1 Q. **Refurbishment of Day Tank.**

Figure 1: Corrosion Rate of Tank Floor Critical Area

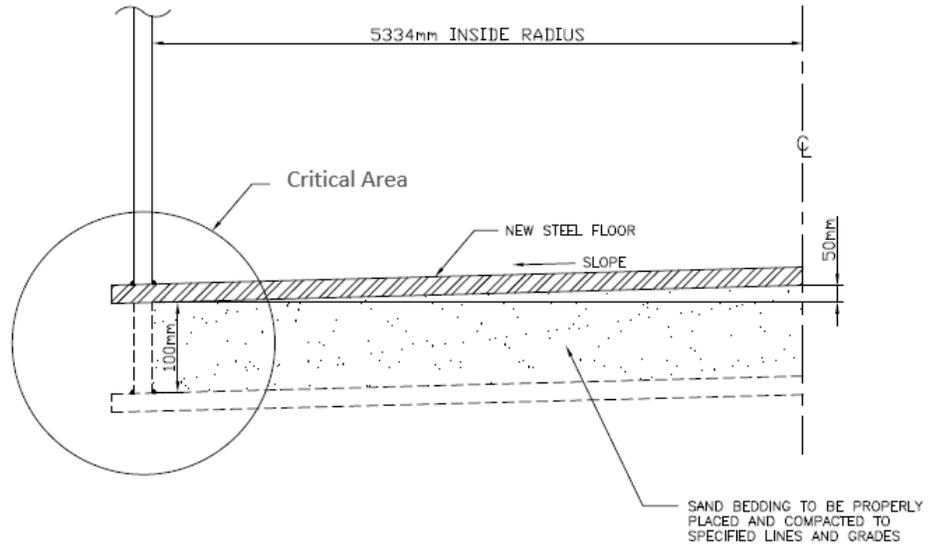
2 With reference to the 2022 CFM report (Schedule 1, Attachment 3), CFM states that in
3 accordance with the API 653 calculations, a minimum of 10% of the existing floor area is
4 required to be replaced. Is Hydro proposing a complete floor replacement? Did Hydro consider,
5 and cost, a 10% replacement?

8 A. Due to the long lead time for floor plates (up to eight months), Newfoundland and Labrador
9 Hydro (“Hydro”) believes it is necessary to order sufficient plates and plan for a complete floor
10 replacement to mitigate the risk that, during work on the floor, the floor is discovered to be in
11 worse condition than expected and requires full replacement. In addition, the full floor
12 replacement will allow for inspecting and replacing any contaminated sand bedding under the
13 floor due to leakage of fuel oil, which will mitigate the environmental risk. Hydro estimated that
14 the budget for a partial replacement of the tank floor could reduce the budget by up to 20%.
15 The cost to clean, inspect, and prepare the tank for the floor work (including jacking up and
16 temporarily supporting the tank) constitutes the bulk of the cost in the proposed project, and
17 would be the same for 100% floor replacement as it would be for 10% floor replacement.

18 Because of this, the potential savings that would be associated with a partial versus a full
19 replacement is small. The corrosion rate of the tank floor critical area (see Figure 1) which was
20 repaired by patching in 2013, indicates that the remaining life of this area cannot exceed ten
21 years. As well, the API 653¹ does not permit installation of patches on top of patches in the
22 critical area; therefore, the previously-repaired sections of the critical area must be replaced.

23 Hydro will inspect and assess the condition of the floor during the proposed project. If the floor
24 is found in considerably better condition than expected, installation of patch plates in some
25 areas may be cheaper than 100% floor replacement, and may realize some cost savings. Hydro
26 will avail of any opportunity to reduce costs by reducing the amount of floor replaced.
